## **WILLIE G MCELROY JR SUBDIVISION**

APPLICATION NUMBER 9 DATE April 1, 2010

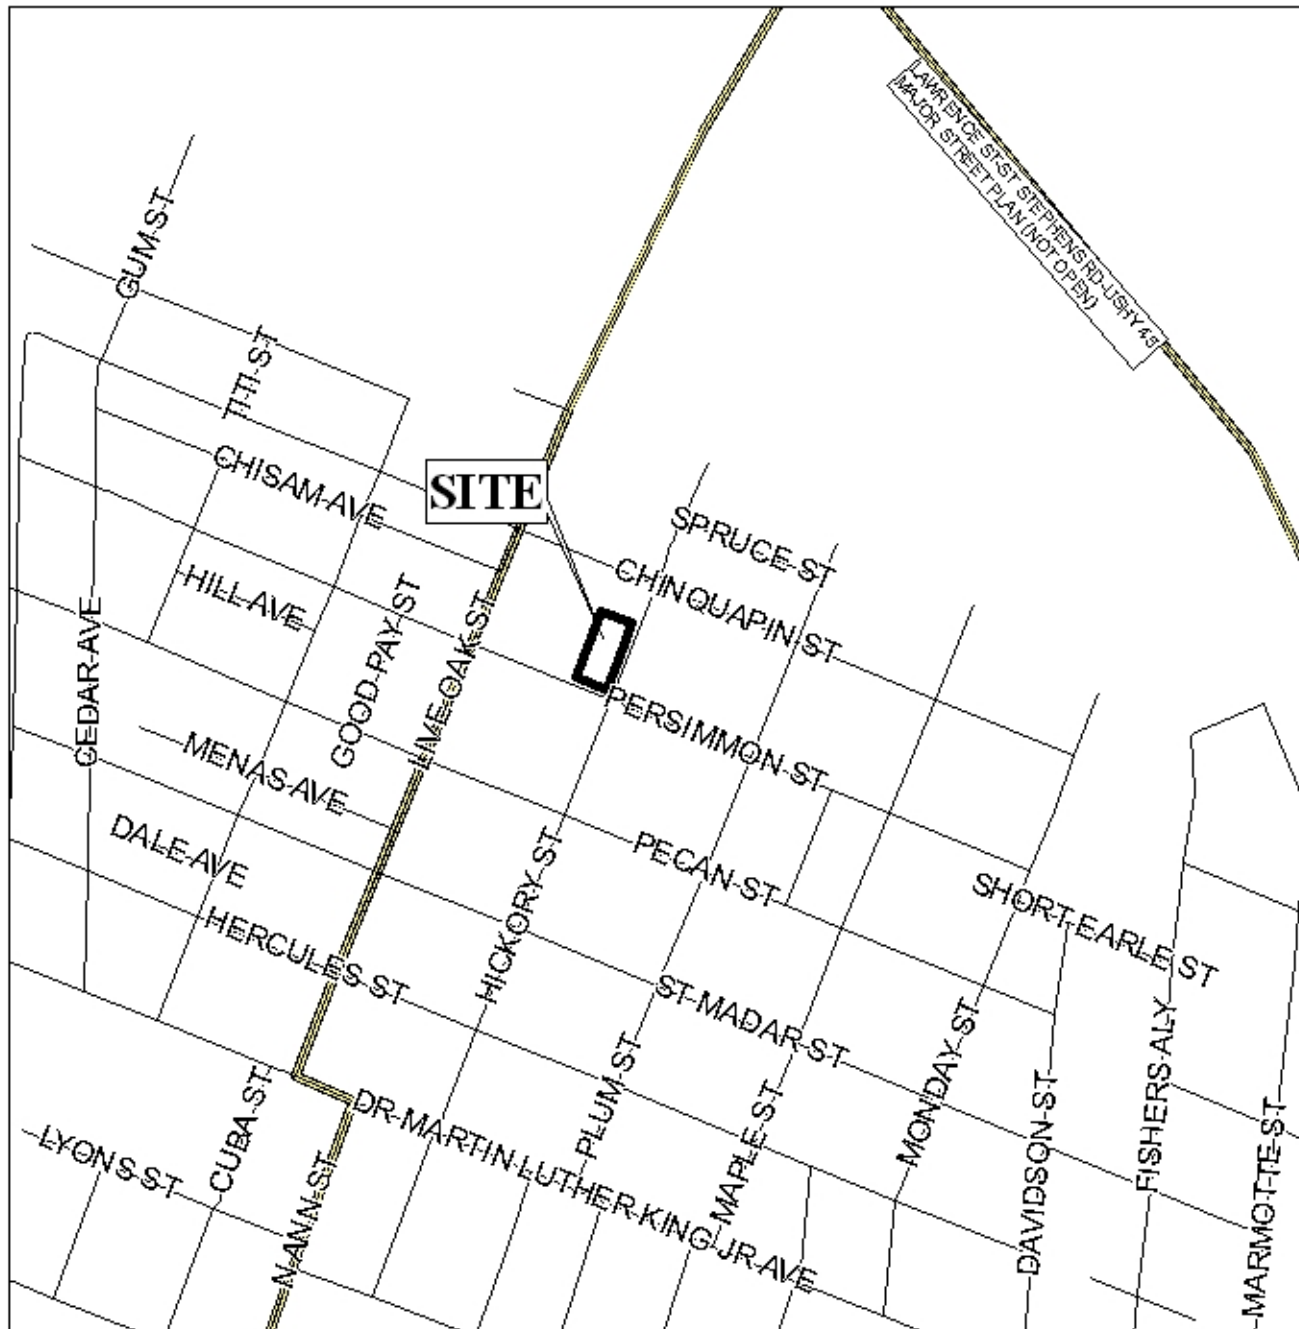
The purpose of this application is to create one legal lot of record from two lots of record and portions of Lots 9 and 10, Block 34 of the Fisher Tract. The excluded portions appear to have been split in 1953, after the adoption of Subdivision Regulations; thus, they should be included in this application.

The site fronts Persimmon Street to the South and Hickory Street to the East, both minor streets with 50' of rights-of-way. It should be noted that Hickory Street does not have curb and gutter. Section V.B.14 of the Subdivision Regulations requires a minimum 60' right-of-way for streets without curb and gutter; therefore, the applicant should revise the plat to dedicate sufficient right-of-way so as to provide a minimum 30' as measured from the centerline of Hickory Street.

The site has approximately 96' and 205' of frontage along Persimmon and Hickory Streets, respectively. As a means of access management, a note should be placed on the final plat stating that the lot is limited to a maximum of one curb cut, with the size, location, and design to be approved by Traffic Engineering and in conformance with AASHTO standards.

A "wood rail" fence is illustrated both at the intersection of the two streets and at the Northeast corner of the lot. Said fence cannot be found on any past photographs of the site. The applicant is advised that, per Section 64-4.D.6 of the Zoning Ordinance, the construction of any fence that obstructs site and greater than 3' in height is prohibited within required front yards.

Based on the preceding, it is recommended that this application be held over until the May 6<sup>th</sup> meeting to allow the applicant to include the remaining portions of Lots 9 and 10, Block 34 of the Fisher Tract (including the provision of new postage fees to allow for corrected notifications). Revisions and fees must be submitted by April 9<sup>th</sup>.
